MERIDIAN STORAGE

LANDSCAPE PLAN

PPR23XX

RESPONSE: REVISED

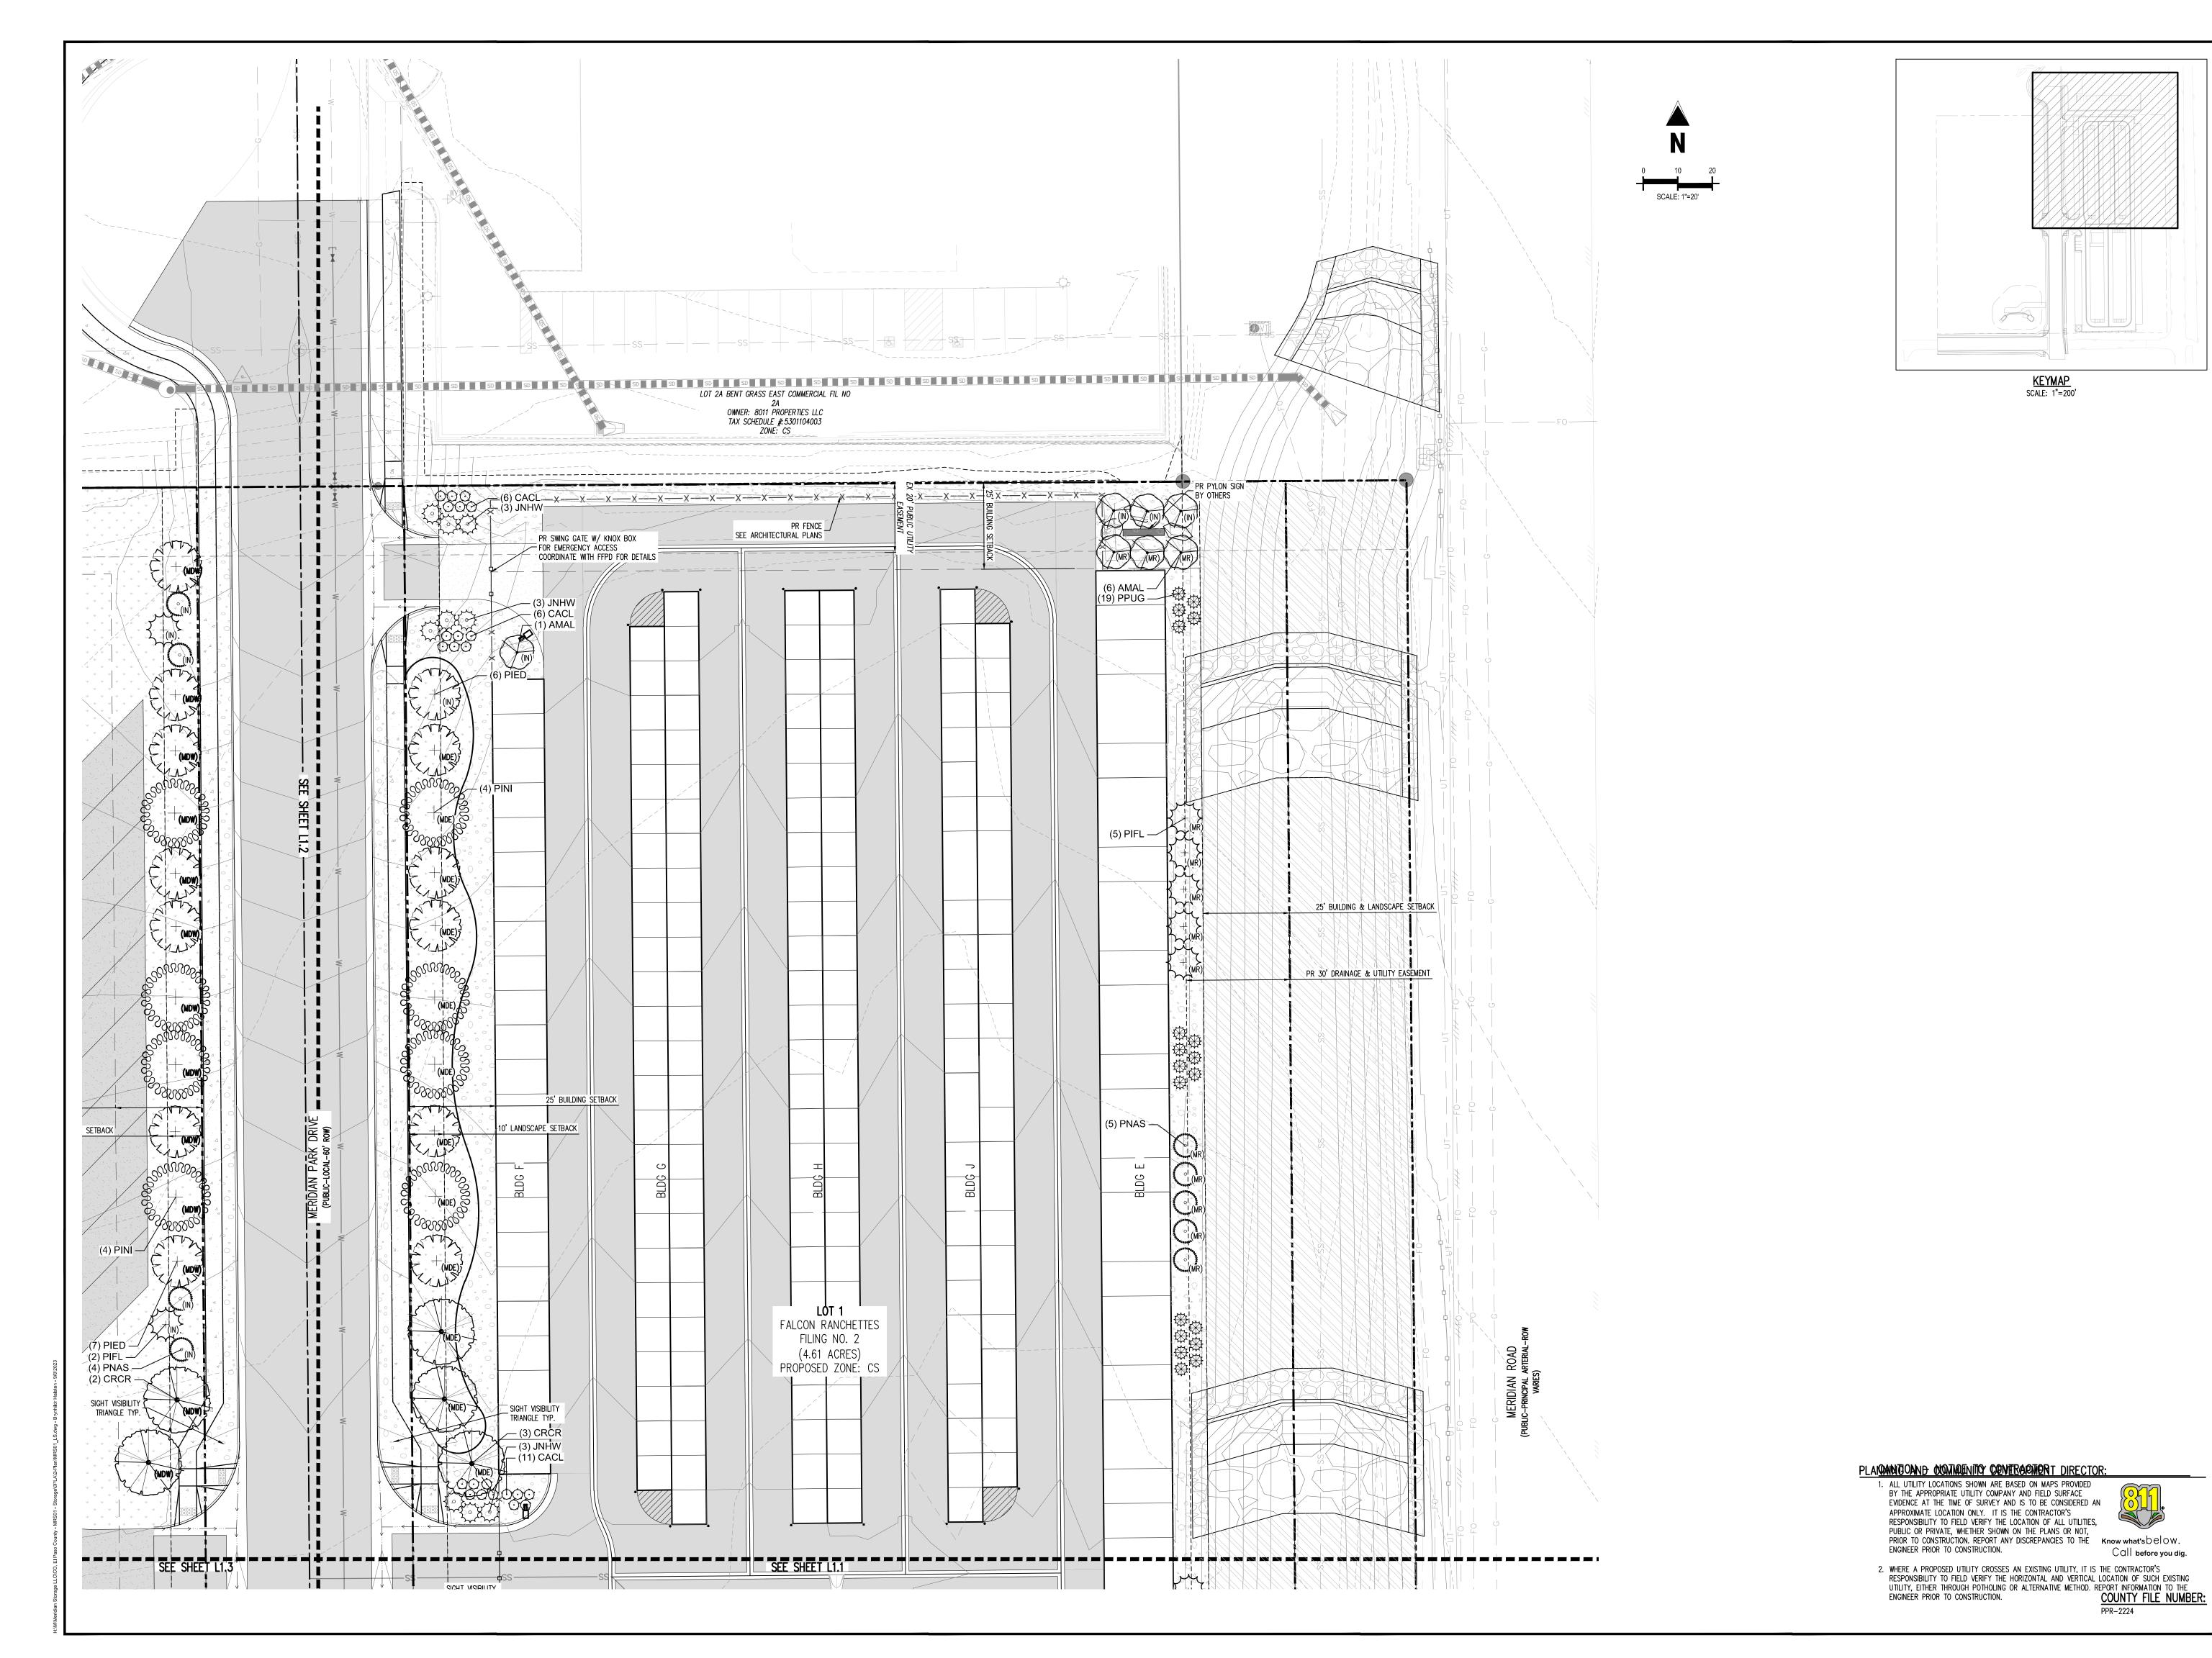
Lot 1 will still require fencing/screen9ing per the code.

> Can it be denoted where the screening/ gates will be in relation to the landscaping? Can the height of the screening please be depicted as well?

RESPONSE: Lot 1 (self storage buildings) is adjacent to Commercially zoned properties and Meridian Road Right of Way. Meridian Road buffers from residential to east. No Screening required.

RESPONSE: PROPOSED **EVERGREEN TREES WILL** PROVIDE SCREENING
